METROPOLITAN GOVERNMENT OF NASHVILLE AND DAVIDSON COUNTY

STAFF RECOMMENDATION
316 South 11th Street
January 18, 2012

Application: New Construction—addition
District: Lockeland Springs-East End Neighborhood Conservation Zoning Overlay
Council District: 06
Map and Parcel Number: 08313008500
Applicant: Peggy Newman
Project Lead: Melissa Baldock, melissa.baldock@nashville.gov

FIRST FLOOR PLAN - 316 S. 11th ST

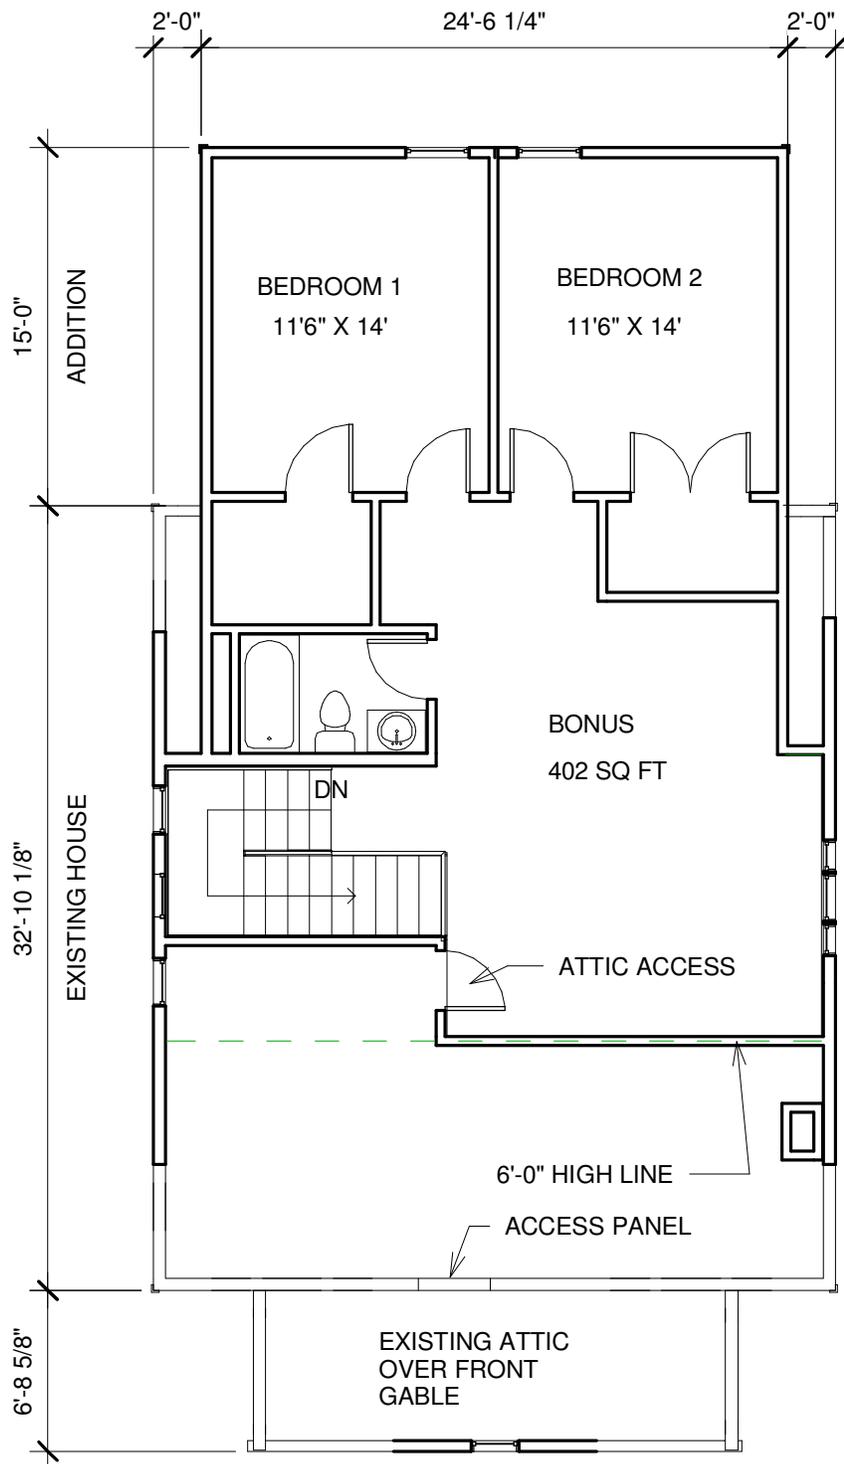
MHZC staff note: Staff recommends stepping in 2' on the right and left sides of the addition so that the wall on the ground floor lines up with the wall on the upper floor.

FRONT ELEVATION - 316 S. 11th St 1/8" = 1'-0"

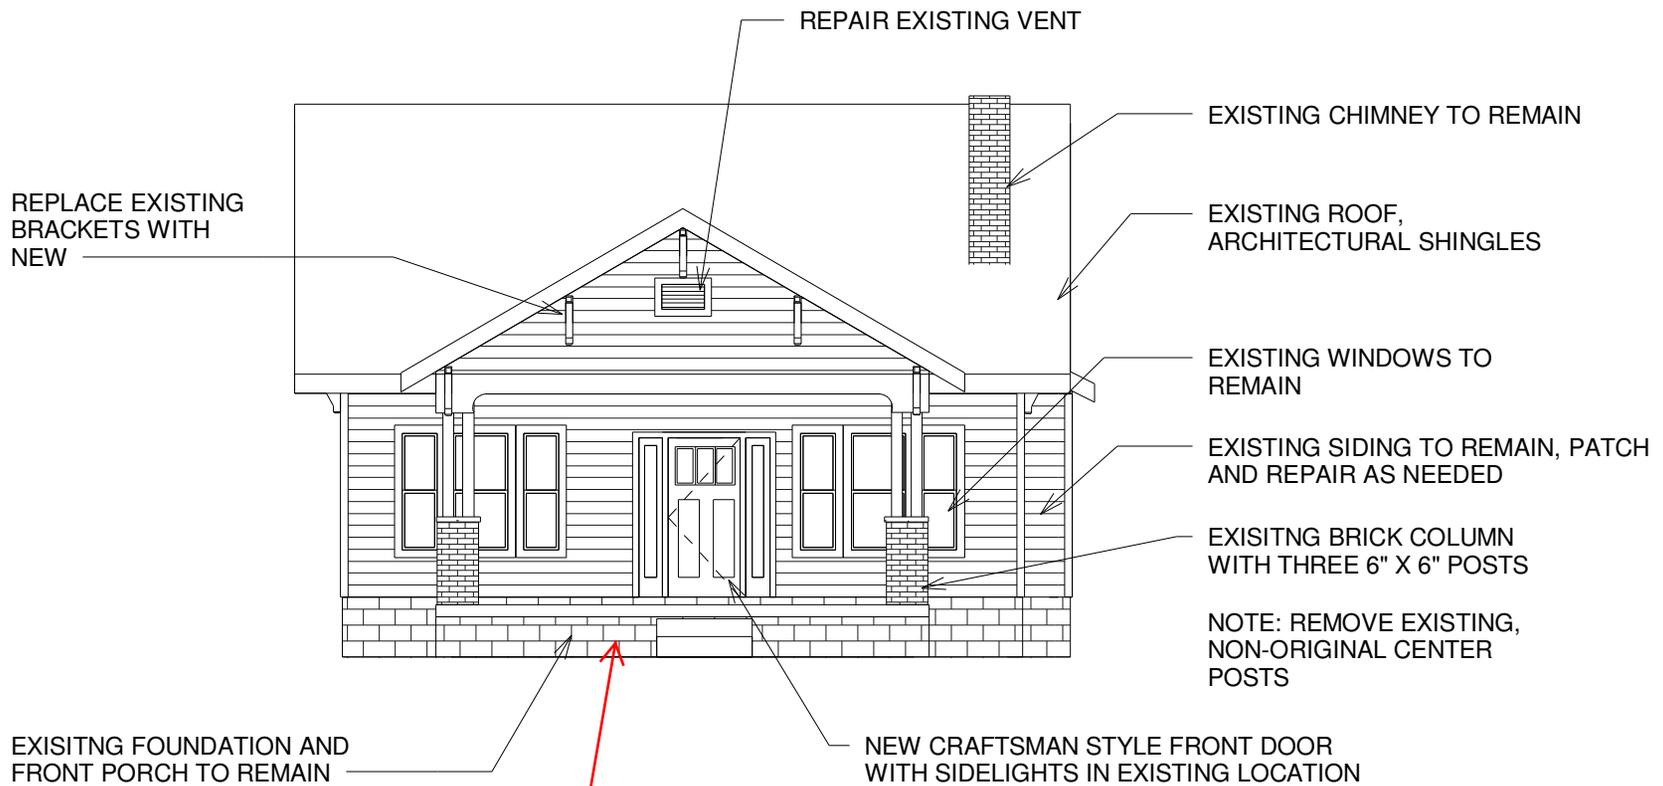
MHZC Staff note:
drawings showing
accurate
foundation height
to be submitted.

LEFT ELEVATION - 316 S. 11th ST 1/8" = 1'-0"

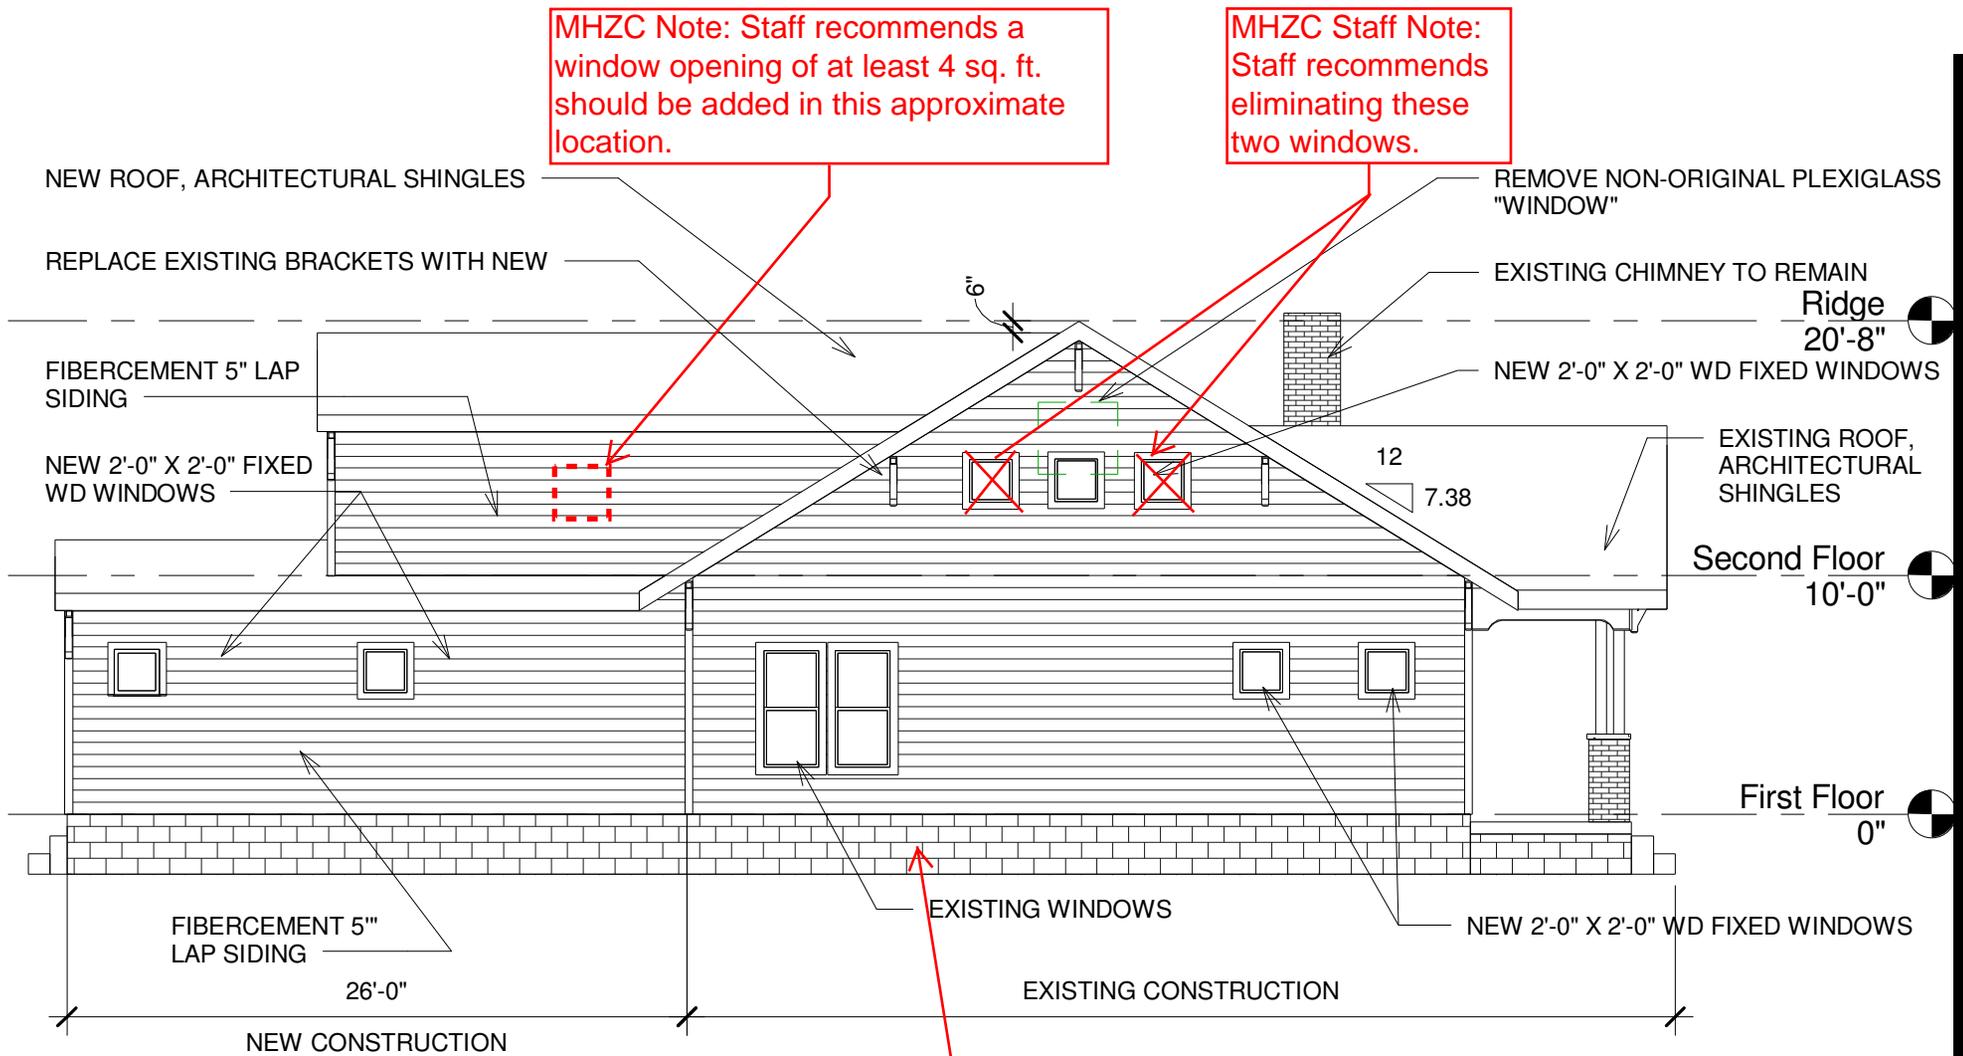
MHZC Staff note:
 drawings showing
 accurate
 foundation height
 to be submitted.

MHZC Note: Staff recommends a window opening of at least 4 sq. ft. should be added in this approximate location.

MHZC Staff Note: Staff recommends eliminating these two windows.

REAR ELEVATION - 316 S. 11th ST

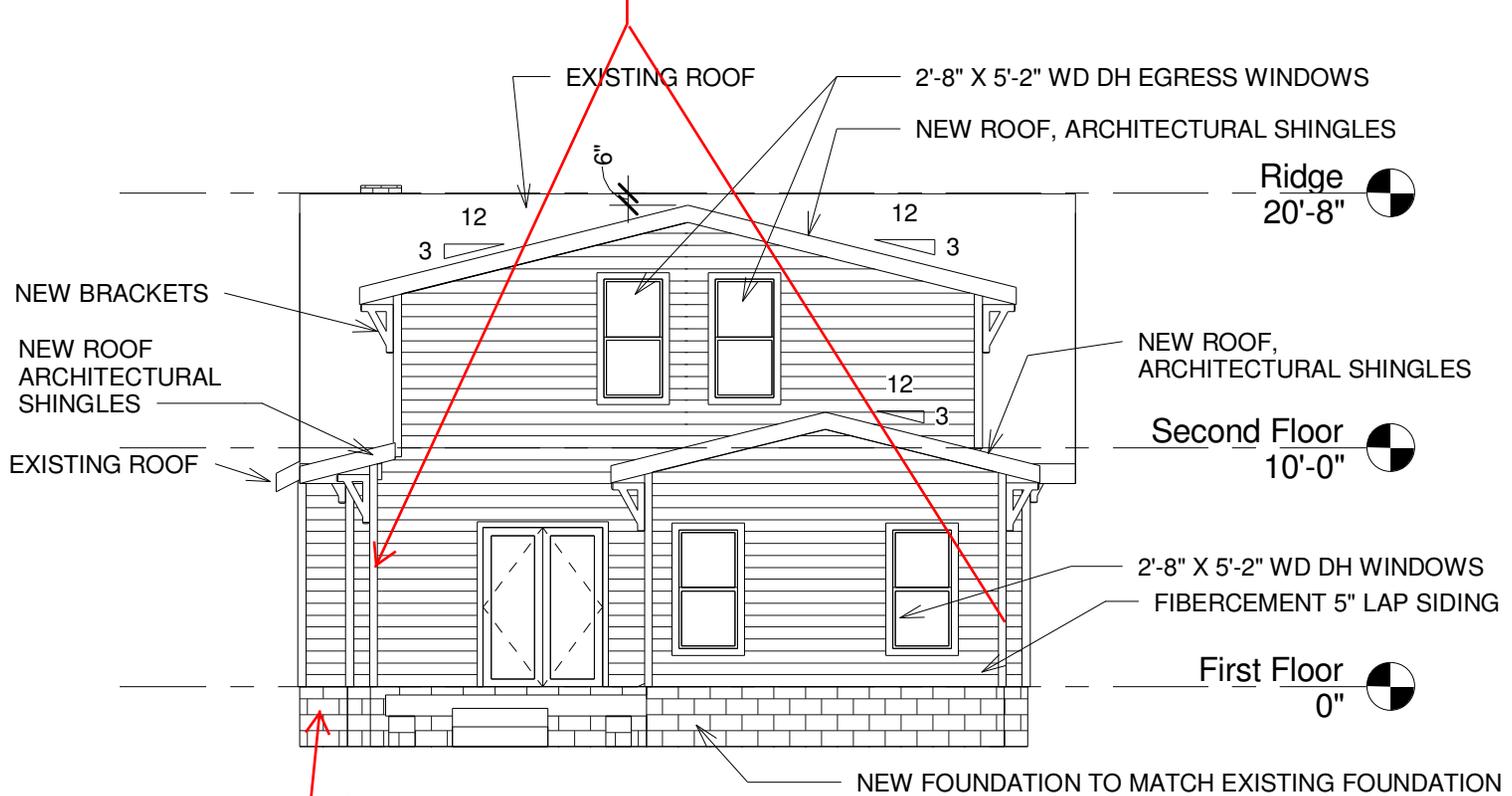
MHZC Staff note: drawings showing accurate foundation height to be submitted.

MHZC Staff note: Staff recommends setting in 2' on each side on the ground floor so that the upper and lower walls of the addition line up.

RIGHT ELEVATION - 316 S. 11th ST

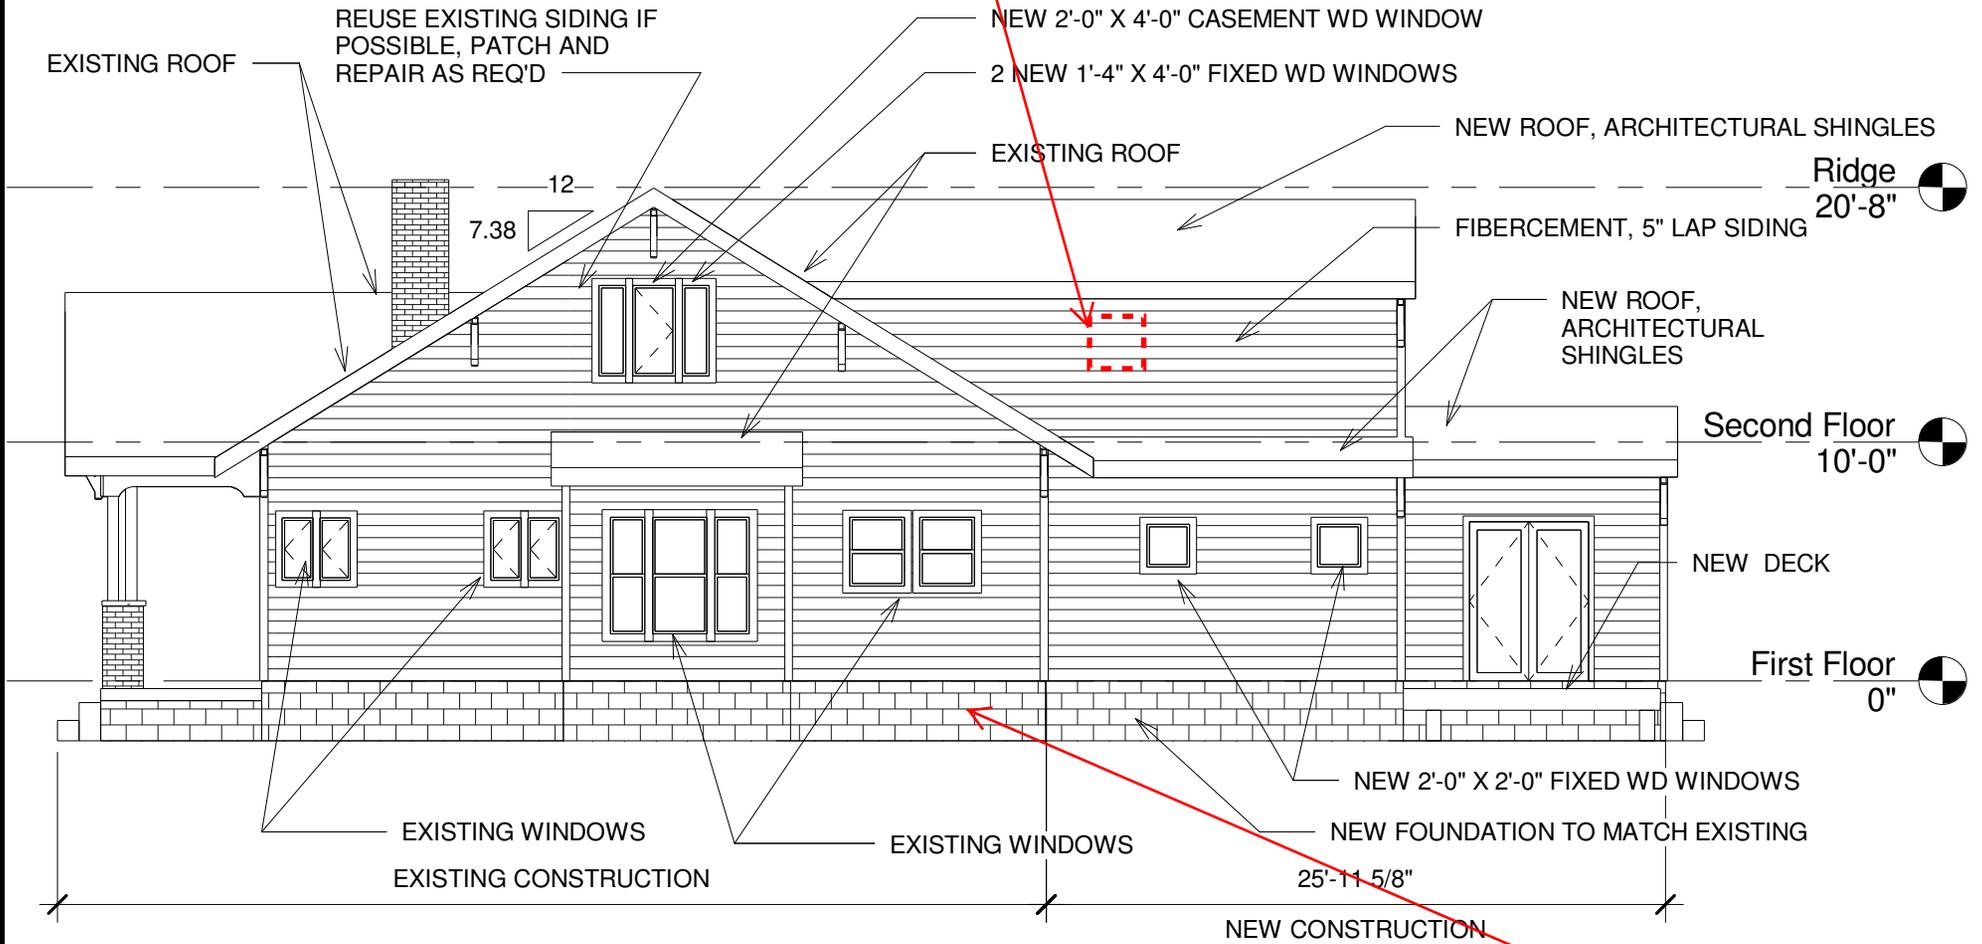
MHZC Staff note: drawings showing accurate foundation height to be submitted.

MHZC Note: Window opening of at least 4 sq. ft. should be added in this approximate location.

MHZC Staff note: drawings showing accurate foundation height to be submitted.
